DART SERVICE INSTRUCTION

TO AMEND DRAWING D350-607 REV. F OR SUBSEQUENT APPROVED REVISION

THE PURPOSE OF THIS DART SERVICE INSTRUCTION (DSI), IS TO PROVIDE OPERATORS OF AS350 / 355 ROTORCRAFT EQUIPPED WITH DART D350-607-041 HELI UTILITY BASKETS WITH AN UPGRADE KIT TO REPLACE THE EXISTING LID PROP ARM WITH 2 GAS SPRINGS.

A	NEW ISSUE	AJS	09.09.15
REV.	DESCRIPTION	BY	DATE
DESIGN	AJS	DART AEROSPACE LTD HAWKESBURY, ONTARIO, CANADA	
DRAWN	AJS		
CHECKED		DRAWING NO.	REV. A
MFG. APPR.	N/A	DSI 9473	SHEET 1 OF 8
APPROVED		TITLE	SCALE
DE APPR.		GAS SPRING UPGRADE KIT	NTS
DATE	09.09.15	COPYRIGHT © 2009 BY DART AEROSPACE LTD <small>THIS DOCUMENT IS PRIVATE AND CONFIDENTIAL AND IS SUPPLIED ON THE EXPRESS CONDITION THAT IT IS NOT TO BE USED FOR ANY PURPOSE OR COPIED OR COMMUNICATED TO ANY OTHER PERSON WITHOUT WRITTEN PERMISSION FROM DART AEROSPACE LTD.</small>

FIGURE 1

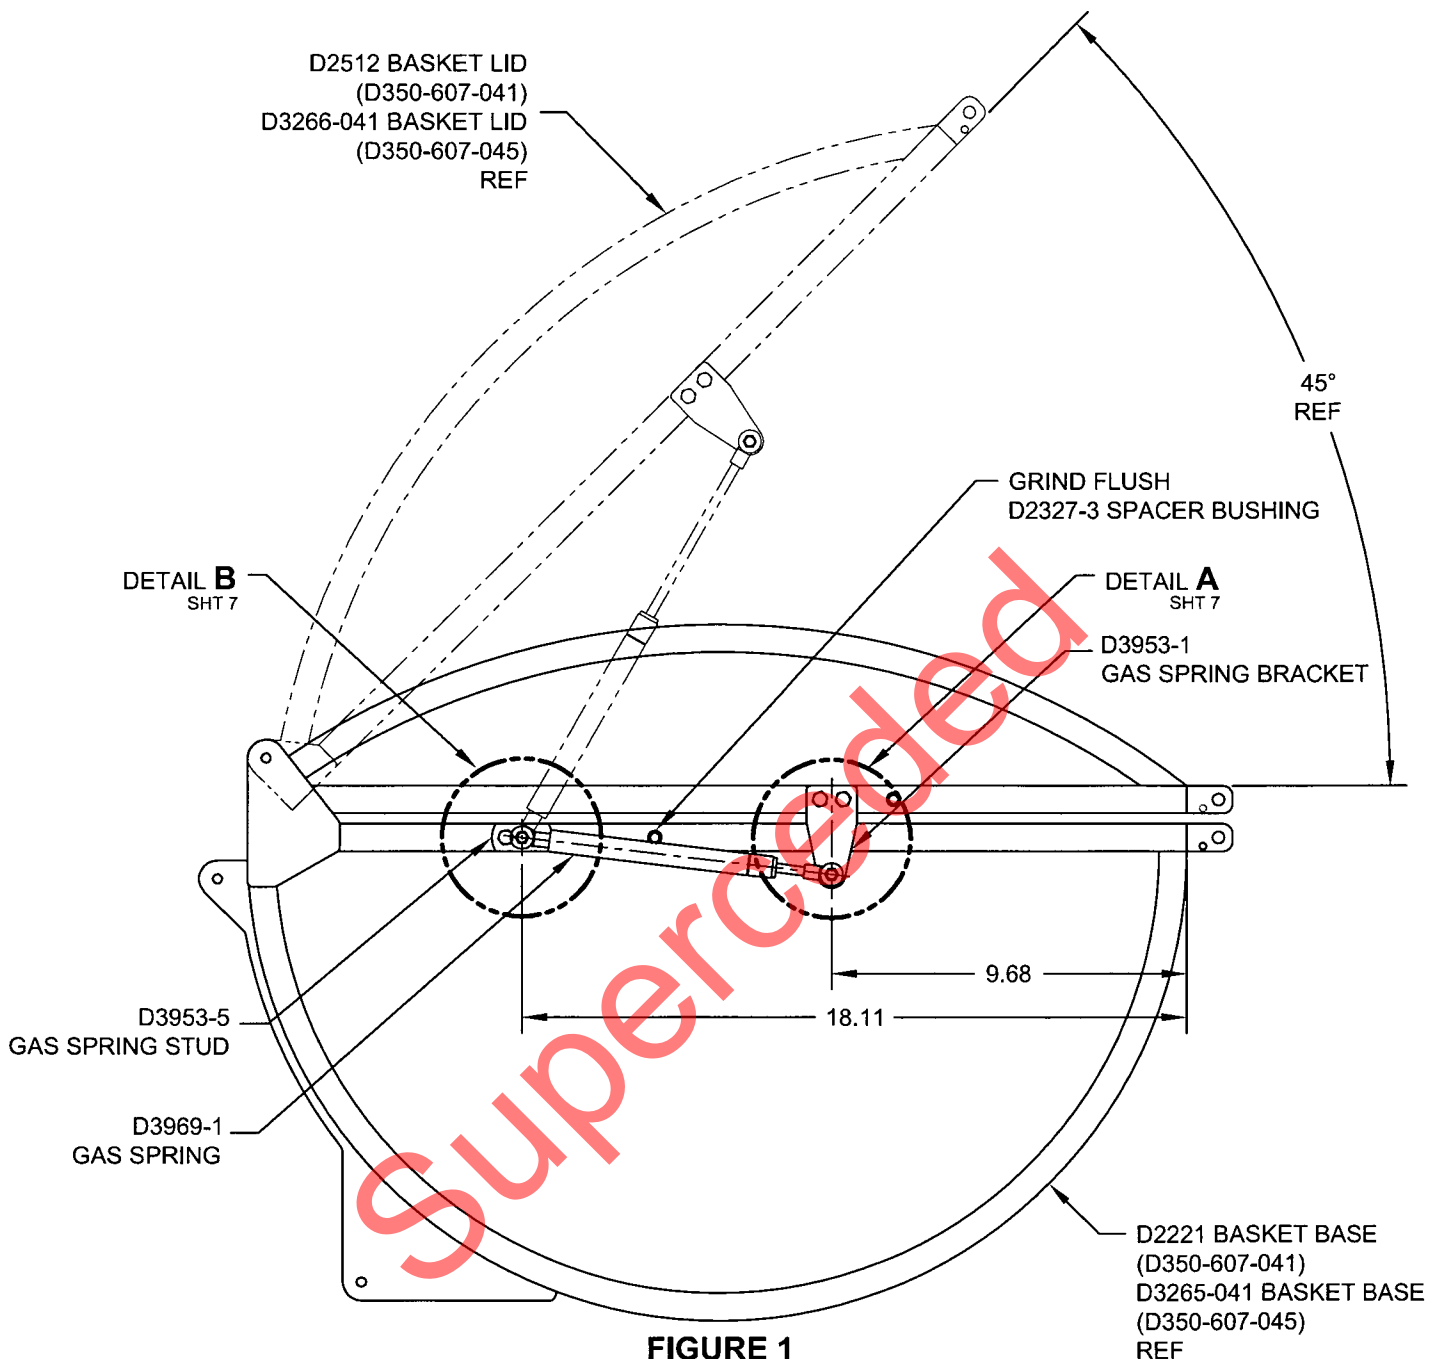
- 1) REMOVE THE D2332-041 PROP ARM.
- 2) GRIND FLUSH THE D2327-3 SPACER BUSHING ON BOTH ENDS OF THE BASKET AS SHOWN IN FIGURE 1 (IT IS PERMISSIBLE TO GRIND ALL 4 SPACERS FLUSH). TOUCH UP PAINT PER ICA-D350-607 REV. 0 SECTION 5.1 ITEM 4.

- 3) LOCATE THE D3953-1 GAS SPRING BRACKET AS SHOWN IN FIGURE 1. TRIM STEEL MESH LOCALLY AS REQUIRED. TOUCH UP PAINT PER ICA-D350-607 REV. 0 SECTION 5.1 ITEM 4. TRANSFER MARK AND DRILL 2X Ø0.194 HOLES THRU THE BASKET LID SQUARE TUBE STRUCTURE AS SHOWN IN DETAIL A. INSTALL THE D3953-1 GAS SPRING BRACKET & D3953-13 GAS SPRING SPACER USING 2X AN3C16A BOLT, 2X NAS1149C0332 WASHER & 2X MS21043-3 NUT AS SHOWN IN VIEW E-E.

- 4) LOCATE THE D3953-5 GAS SPRING STUD AS SHOWN IN FIGURE 1. TRIM STEEL MESH LOCALLY AS REQUIRED. TOUCH UP PAINT PER ICA-D350-607 REV. 0 SECTION 5.1 ITEM 4. TRANSFER MARK AND DRILL 2X Ø0.194 HOLES THRU THE BASKET BASE SQUARE TUBE STRUCTURE AS SHOWN IN DETAIL B. FASTEN D3953-5 IAW VIEW F-F USING 2X AN3C11A BOLT, 2X NAS1149C0332 WASHER & 2X MS21043-3 NUT.

- 1) REMOVE THE D2332-041 PROP ARM.
 - 2) GRIND FLUSH THE D2327-3 SPACER BUSHING ON THE END OF THE BASKET WHERE THE GAS SPRING KIT IS BE INSTALLED AS SHOWN IN FIGURE 1 (IT IS PERMISSIBLE TO GRIND ALL 4 SPACERS FLUSH). TOUCH UP PAINT PER ICA-D350-607 REV. 0 SECTION 5.1 ITEM 4.

- 3) LOCATE THE D3953-1 GAS SPRING BRACKET AS SHOWN IN FIGURE 1. TRIM STEEL MESH LOCALLY AS REQUIRED. TOUCH UP PAINT PER ICA-D350-607 REV. 0 SECTION 5.1 ITEM 4. TRANSFER MARK AND DRILL 2X Ø0.194 HOLES THRU THE BASKET LID SQUARE TUBE STRUCTURE AS SHOWN IN DETAIL A. INSTALL THE D3953-1 GAS SPRING BRACKET & D3953-13 GAS SPRING SPACER USING 2X AN3C16A BOLT, 2X NAS1149C0332 WASHER & 2X MS21043-3 NUT AS SHOWN IN VIEW E-E.

- 4) LOCATE THE D3953-5 GAS SPRING STUD AS SHOWN IN FIGURE 1. TRIM STEEL MESH LOCALLY AS REQUIRED. TOUCH UP PAINT PER ICA-D350-607 REV. 0 SECTION 5.1 ITEM 4. TRANSFER MARK AND DRILL 2X Ø0.194 HOLES THRU THE BASKET BASE SQUARE TUBE STRUCTURE AS SHOWN IN DETAIL B. FASTEN D3953-5 IAW VIEW F-F USING 2X AN3C11A BOLT, 2X NAS1149C0332 WASHER & 2X MS21043-3 NUT.

FIGURE 2
D350-607-143 GAS SPRING KIT INSTALLATION
 (1 END ONLY)

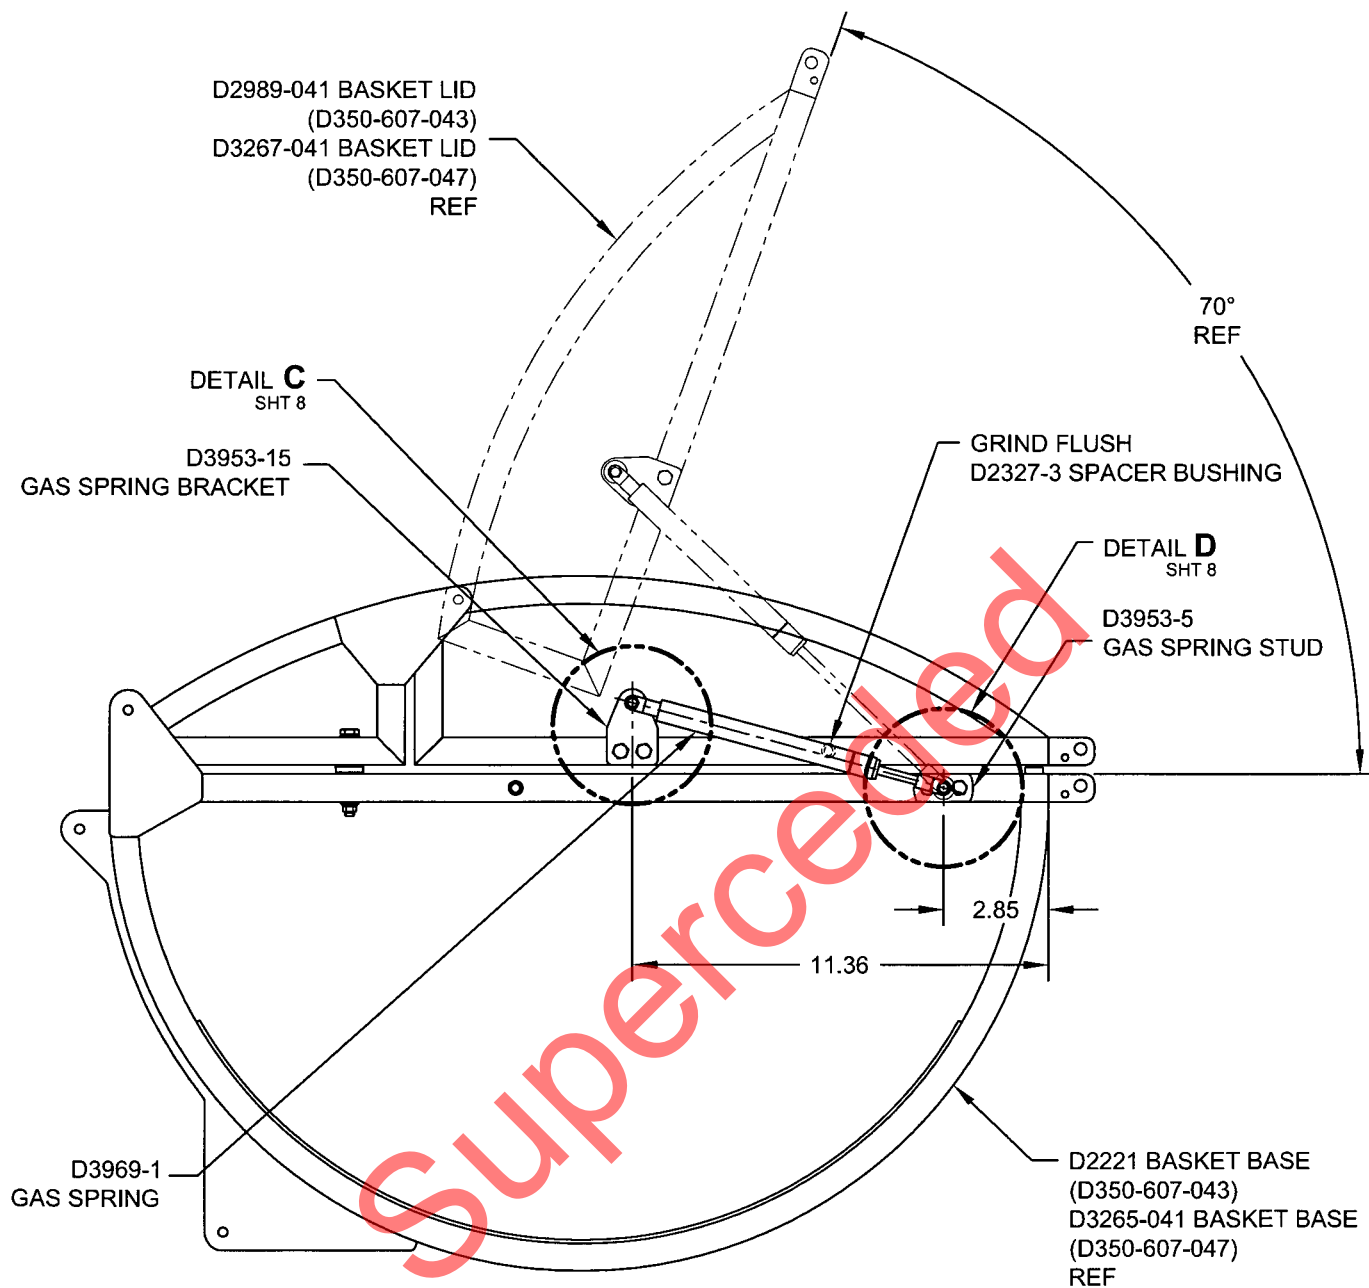
- 1) REMOVE THE D2332-041 PROP ARM.
 - 2) GRIND FLUSH THE D2327-3 SPACER BUSHING ON THE END OF THE BASKET WHERE THE GAS SPRING KIT IS BE INSTALLED AS SHOWN IN FIGURE 2 (IT IS PERMISSIBLE TO GRIND ALL 4 SPACERS FLUSH). TOUCH UP PAINT PER ICA-D350-607 REV. 0 SECTION 5.1 ITEM 4.

- 3) LOCATE THE D3953-15 GAS SPRING BRACKET AS SHOWN IN FIGURE 2. TRIM STEEL MESH LOCALLY AS REQUIRED. TOUCH UP PAINT PER ICA-D350-607 REV. 0 SECTION 5.1 ITEM 4. TRANSFER MARK AND DRILL 2X Ø0.194 HOLES THRU THE BASKET LID SQUARE TUBE STRUCTURE AS SHOWN IN DETAIL C. INSTALL THE D3953-15 GAS SPRING BRACKET & D3953-17 GAS SPRING SPACER USING 2X AN3C15A BOLT, 2X NAS1149C0332 WASHER & 2X MS21043-3 NUT AS SHOWN IN VIEW G-G.

- 4) LOCATE THE D3953-5 GAS SPRING STUD AS SHOWN IN FIGURE 2. TRIM STEEL MESH LOCALLY AS REQUIRED. TOUCH UP PAINT PER ICA-D350-607 REV. 0 SECTION 5.1 ITEM 4. TRANSFER MARK AND DRILL 2X Ø0.194 HOLES THRU THE BASKET BASE SQUARE TUBE STRUCTURE AS SHOWN IN DETAIL D. INSTALL 2X AN3C11A BOLT, 2X NAS1149C0332 WASHER & 2X MS21043-3 NUT AS SHOWN IN VIEW H-H. INSTALL THE ROD END OF THE D3969-1 GAS SPRING ONTO THE D3953-3 GAS SPRING STUD USING 1X D3953-9 GAS SPRING WASHER, 1X NAS1149C0432H WASHER, 1X AN310-4 CASTELATTED NUT & 1X MS24665-212 COTTER PIN AS SHOWN IN VIEW H-H. INSTALL COTTER PIN PER MS33540 OR AC43.13 CHAPTER 7-127.

- 5) INSERT THE D3953-3 GAS SPRING STUD INTO THE D3953-15 GAS SPRING BRACKET & INSERT THE D3953-7 GAS SPRING SPACER ONTO THE D3953-3 GAS SPRING STUD AS SHOWN IN VIEW G-G. RAISE THE BASKET LID AND INSTALL THE D3969-1 GAS SPRING ONTO THE D3953-3 GAS SPRING STUD AND FASTEN IN PLACE USING 1X D3953-9 GAS SPRING WASHER, 1X NAS1149C0432H WASHER, 1X AN310-4 CASTELATTED NUT & 1X MS24665-212 COTTER PIN AS SHOWN IN VIEW G-G. INSTALL COTTER PIN PER MS33540 OR AC43.13 CHAPTER 7-127.

VIEW F-F

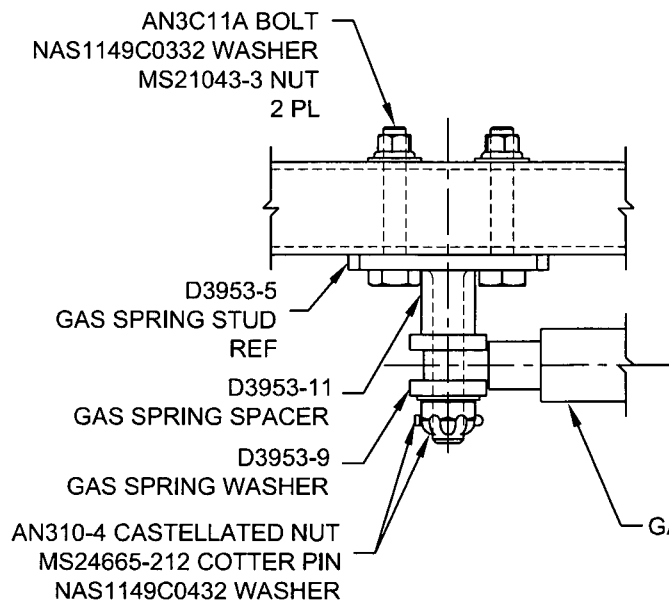
- 5) INSTALL 1X D3953-11 GAS SPRING SPACER ONTO THE D3953-5 STUD AS SHOWN IN VIEW F-F. INSTALL THE LARGE END OF THE D3969-1 GAS SPRING SPRING ONTO THE D3953-5 GAS SPRING STUD AND FASTEN IN PLACE USING 1X D3953-9 GAS SPRING WASHER, 1X NAS1149C0432H WASHER, 1X AN310-4 CASTELATTED NUT & 1X MS24665-212 COTTER PIN AS SHOWN IN VIEW F-F. INSTALL COTTER PIN PER MS33540 OR AC43.13 CHAPTER 7-127.

- 5) INSTALL 1X D3953-11 GAS SPRING SPACER ONTO THE D3953-5 STUD AS SHOWN IN VIEW F-F. INSTALL THE LARGE END OF THE D3969-1 GAS SPRING SPRING ONTO THE D3953-5 GAS SPRING STUD AND FASTEN IN PLACE USING 1X D3953-9 GAS SPRING WASHER, 1X NAS1149C0432H WASHER, 1X AN310-4 CASTELATTED NUT & 1X MS24665-212 COTTER PIN AS SHOWN IN VIEW F-F. INSTALL COTTER PIN PER MS33540 OR AC43.13 CHAPTER 7-127.

VIEW E-E

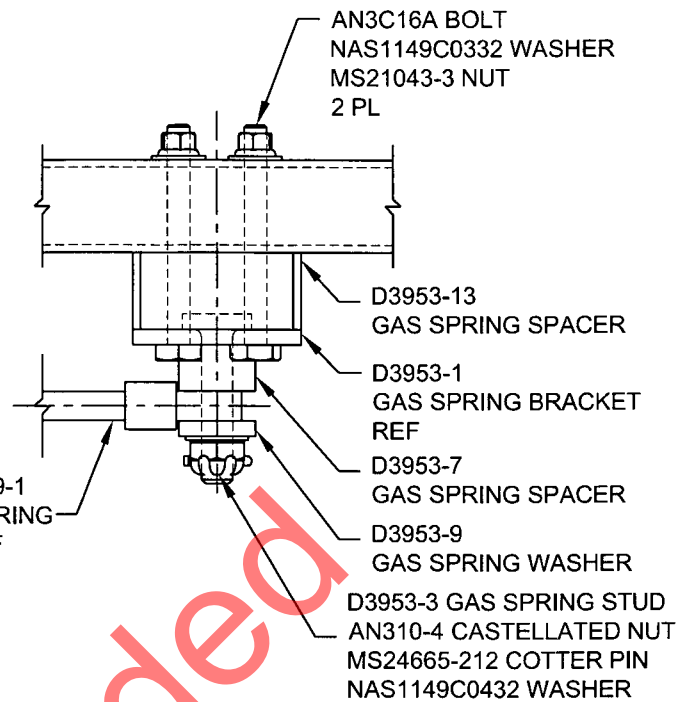
- 6) INSERT THE D3953-3 GAS SPRING STUD INTO THE D3953-1 GAS SPRING BRACKET & INSERT THE D3953-7 GAS SPRING SPACER ONTO THE D3953-3 GAS SPRING AS SHOWN IN VIEW E-E. RAISE THE BASKET LID AND INSTALL THE ROD END OF THE D3969-1 GAS SPRING ONTO THE D3953-3 GAS SPRING STUD USING 1X D3953-9 GAS SPRING WASHER, 1X NAS1149C0432H WASHER, 1X AN310-4 CASTELATTED NUT & 1X MS24665-212 COTTER PIN AS SHOWN IN VIEW E-E. INSTALL COTTER PIN PER MS33540 OR AC43.13 CHAPTER 7-127.

- 6) INSERT THE D3953-3 GAS SPRING STUD INTO THE D3953-1 GAS SPRING BRACKET & INSERT THE D3953-7 GAS SPRING SPACER ONTO THE D3953-3 GAS SPRING AS SHOWN IN VIEW E-E. RAISE THE BASKET LID AND INSTALL THE ROD END OF THE D3969-1 GAS SPRING ONTO THE D3953-3 GAS SPRING STUD USING 1X D3953-9 GAS SPRING WASHER, 1X NAS1149C0432H WASHER, 1X AN310-4 CASTELATTED NUT & 1X MS24665-212 COTTER PIN AS SHOWN IN VIEW E-E. INSTALL COTTER PIN PER MS33540 OR AC43.13 CHAPTER 7-127.
